SUBJECT: ROCKWELL HANFORD OPERATIONS DOCUMENT SD-BWI-TI-109,
"... HYDRAULIC TESTING OF MIDDLE SENTINEL BLUFFS..."

WASTE MANAGEMENT DOCUMENT REVIEW

DOCUMENT: Preliminary Results of Hydraulic Testing of the Middle Sentinel Bluffs Basalt Colonnade/Entablature (3175-3244) feet at Borehole RRL-2, Rockwell Hanford Operations (RHO), SD-BWI-TI-109, released January 1983.

Figure 1. Flowrate vs. transmissivity for each step.
 TI-109 Cohasset Interior
 4 Step Injection Test

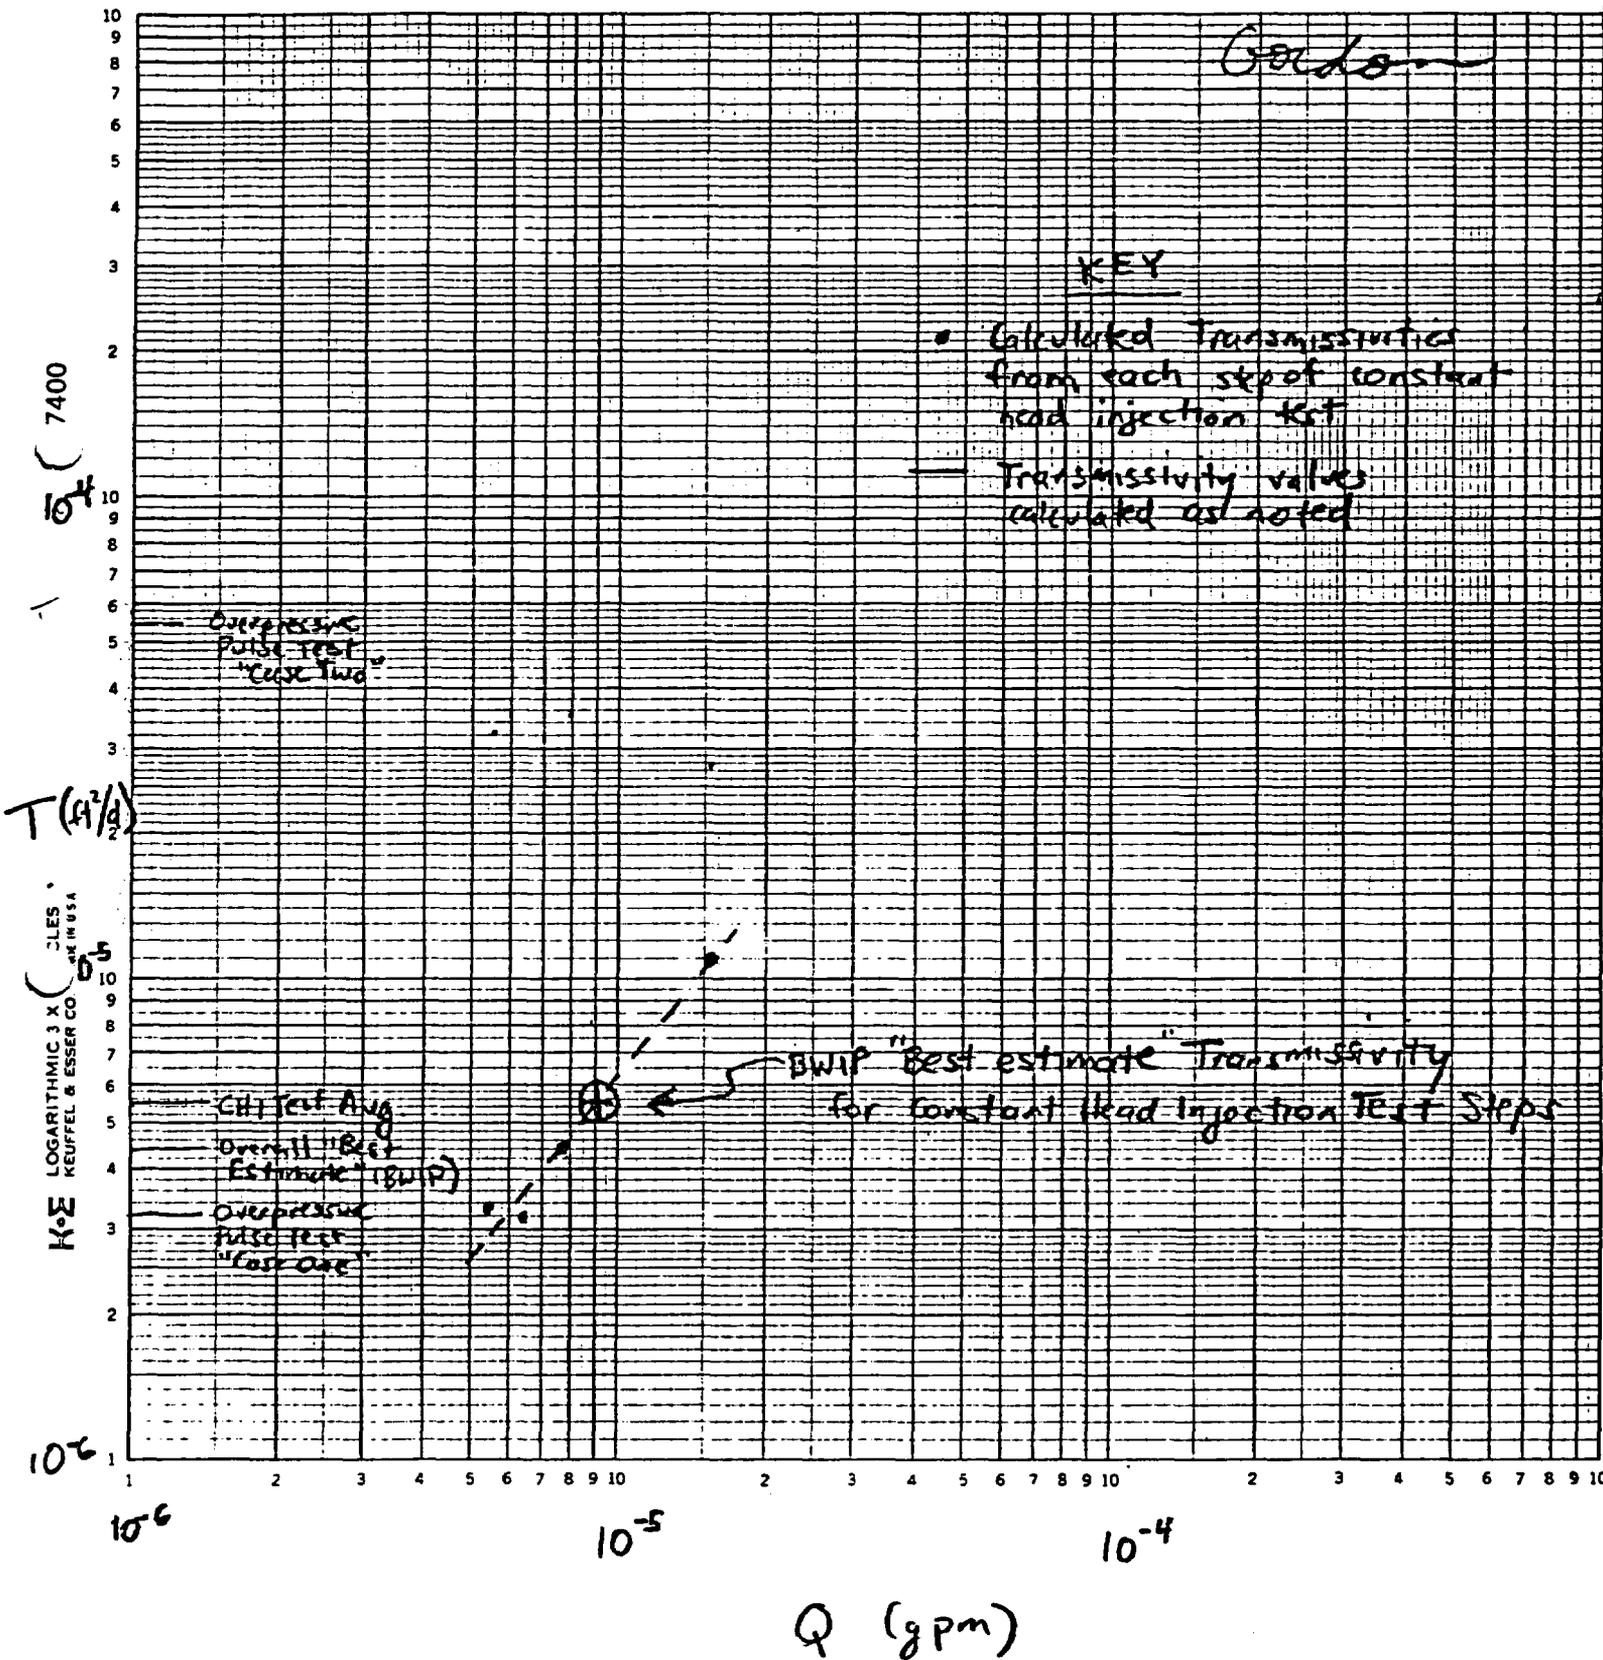
BWIP does not indicate the temperature of injected fluid; this could make their estimates of imposed heads erroneous, as NRC has pointed out in reference to other tests at BWIP (c.f., Wright to Olson, May 25, 1984). Regardless of this point, however, the results presented by BWIP in Table 2 of the subject report (attached) indicate substantial irregularities in these tests. Figure 1 shows the calculated transmissivities as a function of the steady-state flow rates for each step. These should theoretically plot along a straight horizontal line. Figure 2 shows the steady flow rate as a function of the imposed head. This should plot as a straight line of positive slope with flow (Q)=0 intercept at imposed head (H)=0. However, this is not the case for the BWIP tests. For example, the BWIP tests indicate that the lowest head imposition required the highest flow rate to maintain, which is contrary to the theoretical response. The only portion of the plot which even has positive slope is section B; however, this section has a Q-intercept (H=0) at $-1.56e-5$ gpm, rather than zero.
